Re: **Flood Plain Determination, for 2662 Hwy 93 South, Darby, Mt.
Jeffrey & Barbara Black:
Your Denial Letter of January 12, 2012**

This letter is a PRELIMINARY REQUEST to APPEAL your Denial letter of January 12, 2012 denying a proper floodplain determination for the above referenced project as previously requested. A formal Request to Appeal your determination is pending.

Comparison Review of FEMA and Flood Plain Management Study

2/24

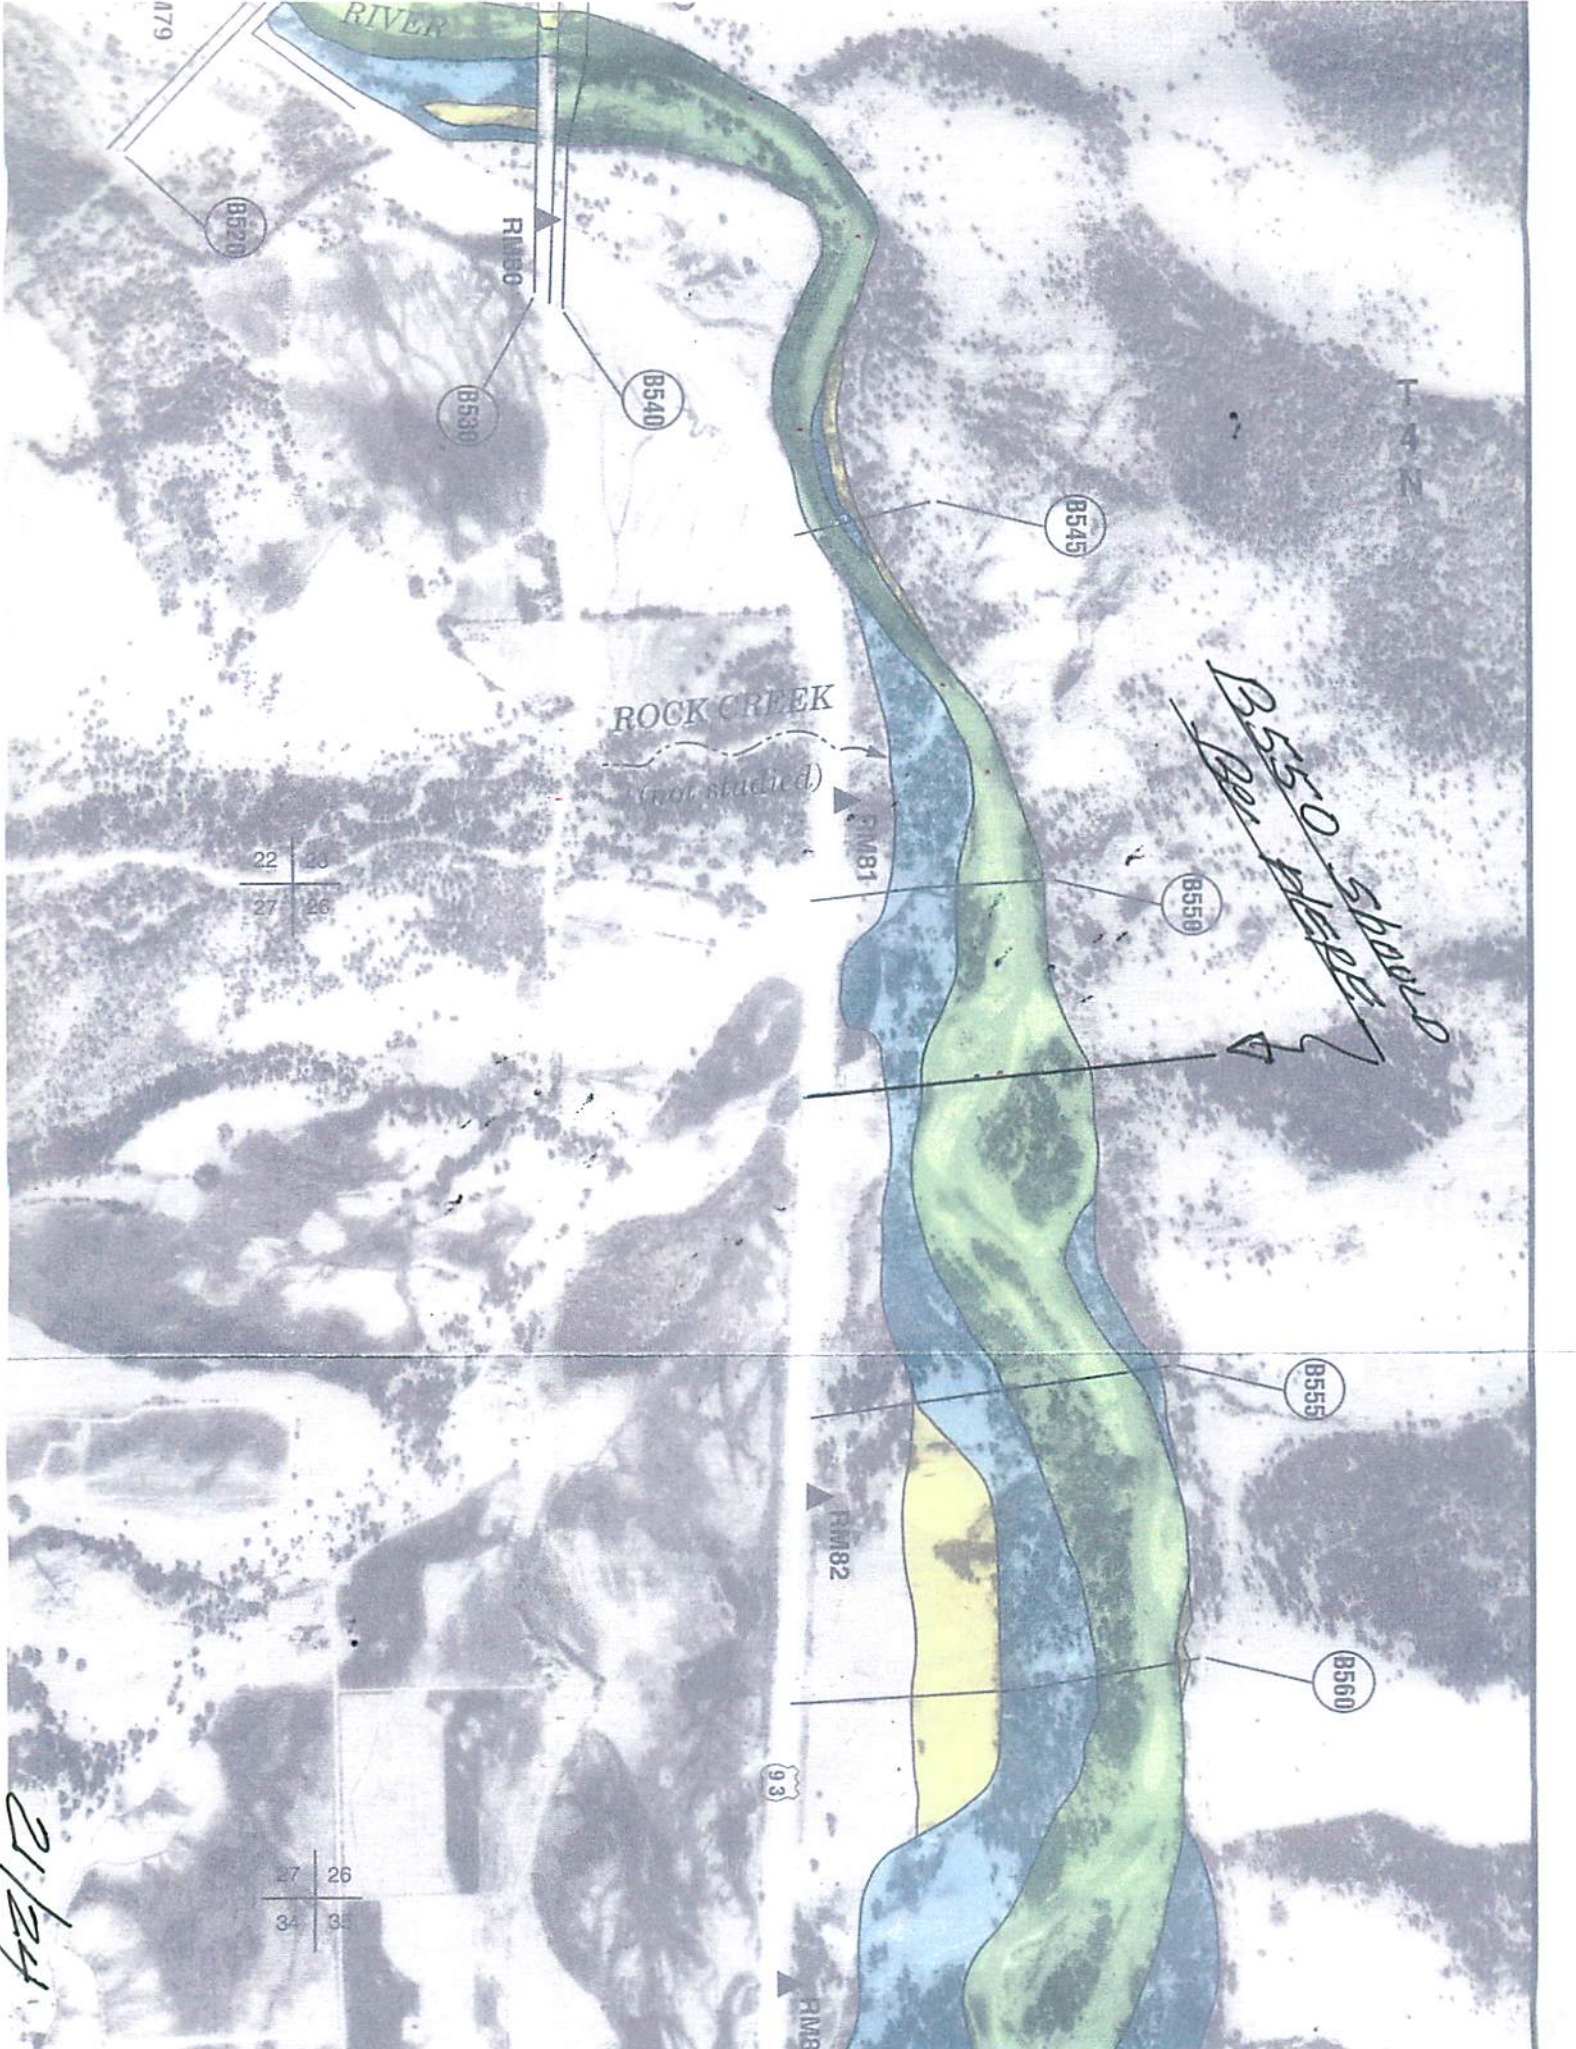
B550 SHOULD BE RM81

* B550 is drawn on the plat sheet 21 of 24 at 262100 >>should be @ 263100
Its drawn 1000 ft off.

1. FEMA profile 11P is not drawn the same as the FPMS sheet 11 of 13. Copy of the comparison attached. I made a composite sheet out of both so that they can be easily compared.
2. Cross Section Notes, Actual for B550 do not match the location where B550 is drawn on sheet 21 of 24.
3. Cross Section B550 fit's the new location where shown on the Aerial Photo, Copy attached. When this Cross section location is then plotted on the Aerial Photo it then matches the profile and all slopes and Station then match out.
